September 7, 2021

El Paso County  
Planning and Community Development Department  
2880 International Circle, Suite 110  
Colorado Springs, CO 80910

Re: Colorado Springs Utilities – Northeast Gravel Staging Area  
El Paso County Drainage Letter

Proposed 10 year

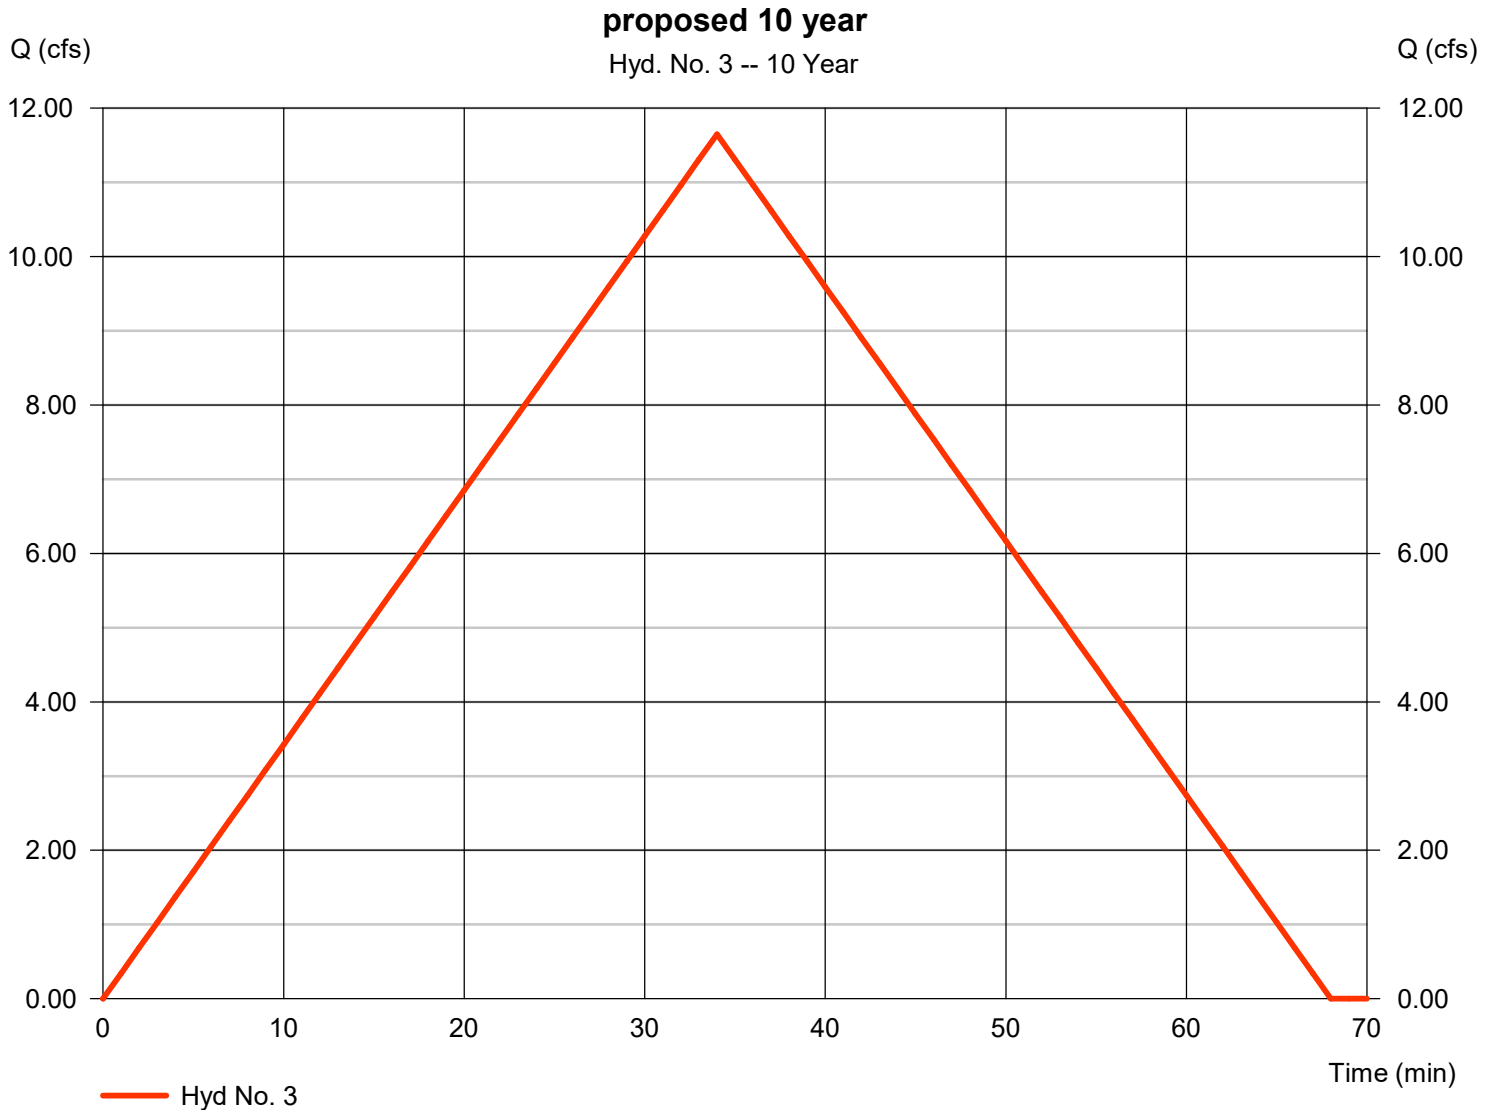
Please update point name to be consistent with report and Pre-Development Plan.

Proposed 100 year

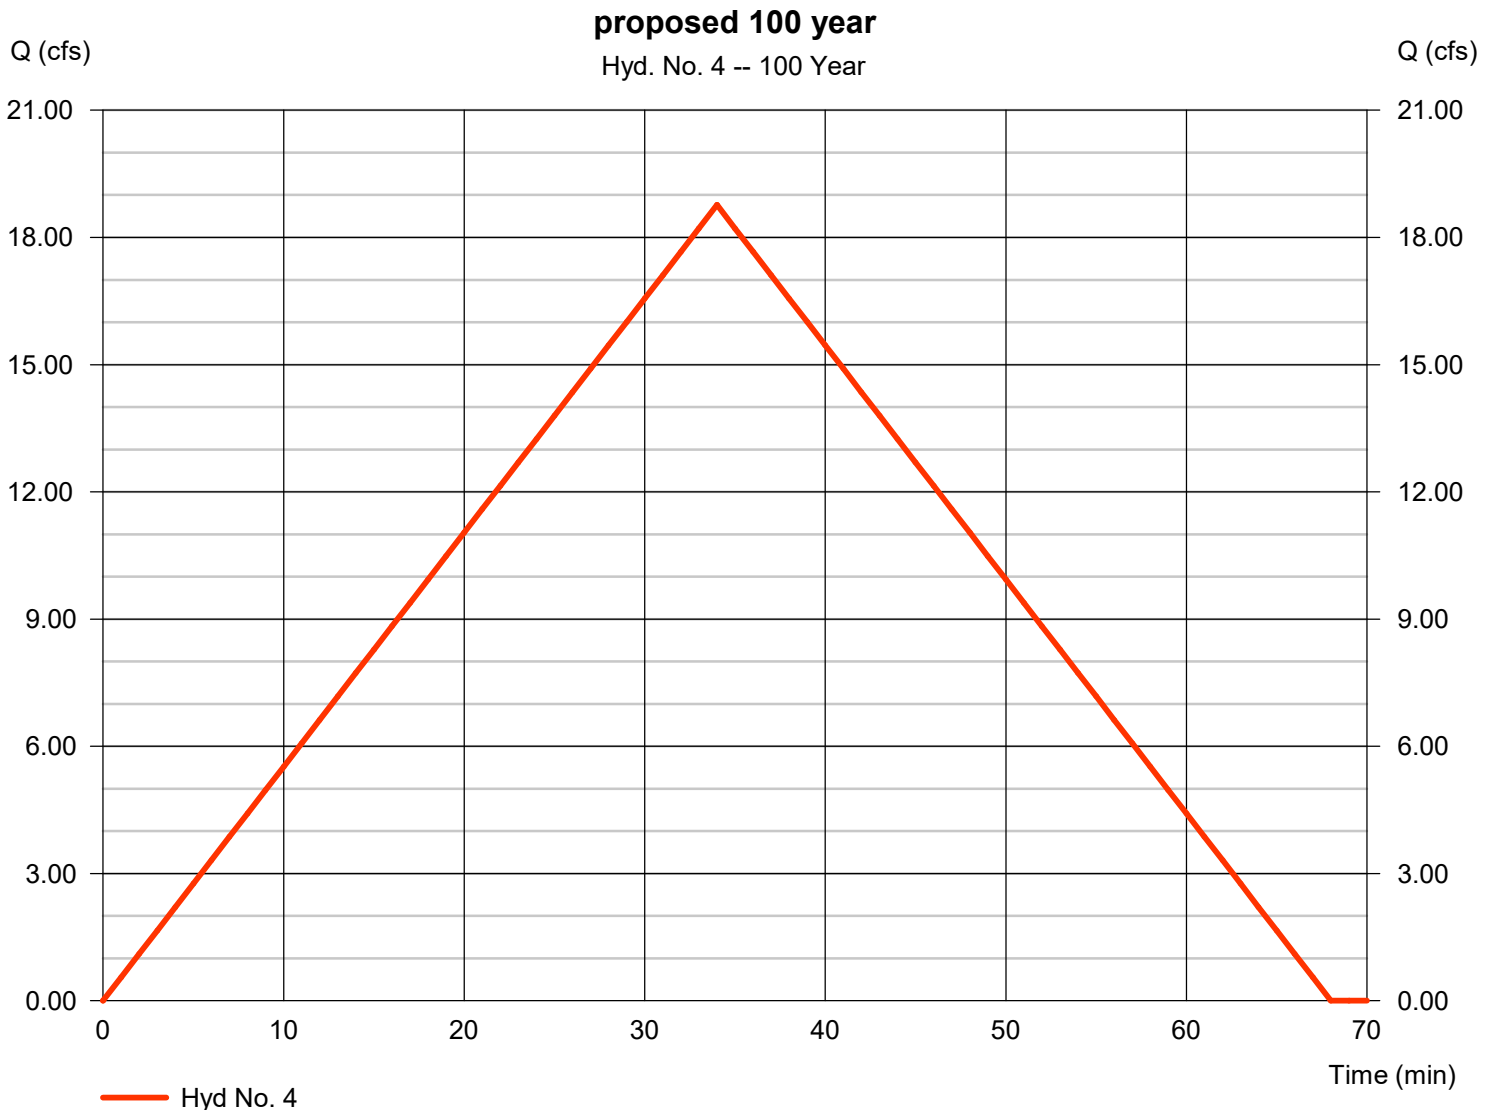
Please update point name to be consistent with report and Pre-Development Plan.
